IMPROVEMENT PERMIT / AUTHORIZATION TO CONSTRUCT / OPERATION PERMIT / EXISTING SYSTEM INSPECTION

PERMIT# 87087 PIN# 4701980342 DATE JAN 12-2000

SUBDIVISION Top of the LAKE BLOCK / SECTION LOT 18/19 LOT AREA 1Ac Plus SITE CLASS PS DESIGN FLOW 360 L.T.A.R. .03

INITIAL SITE SKETCH

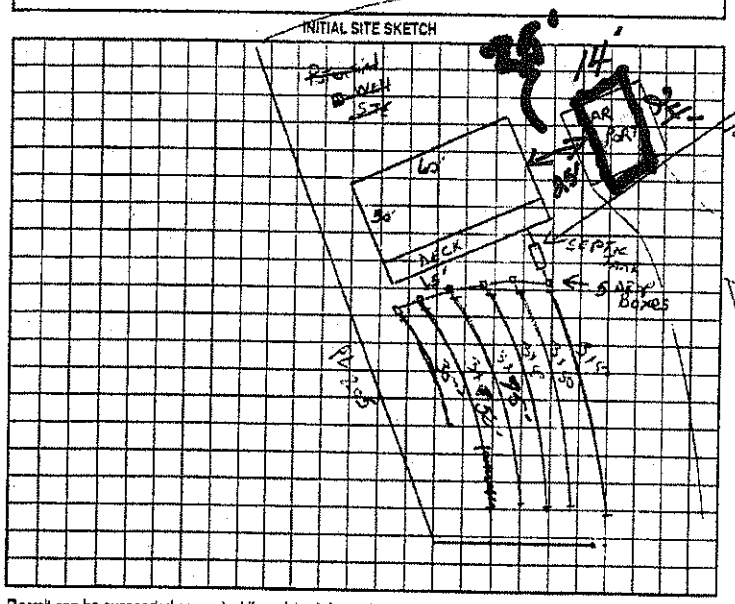
Comments/Conditions: INSTALLation CONTOUR
Locate well 100ft from Septic system Lake Top Lane

AS BUILT SKETCH

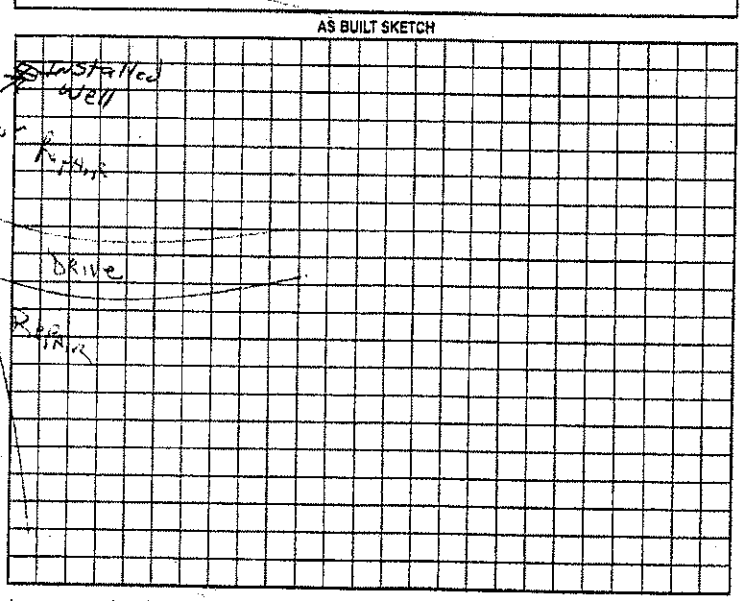
Location of the proposed 14'X24' Acc. Bldg. addition does not appear to impact the existing on-site septic system or well.NOTE:**
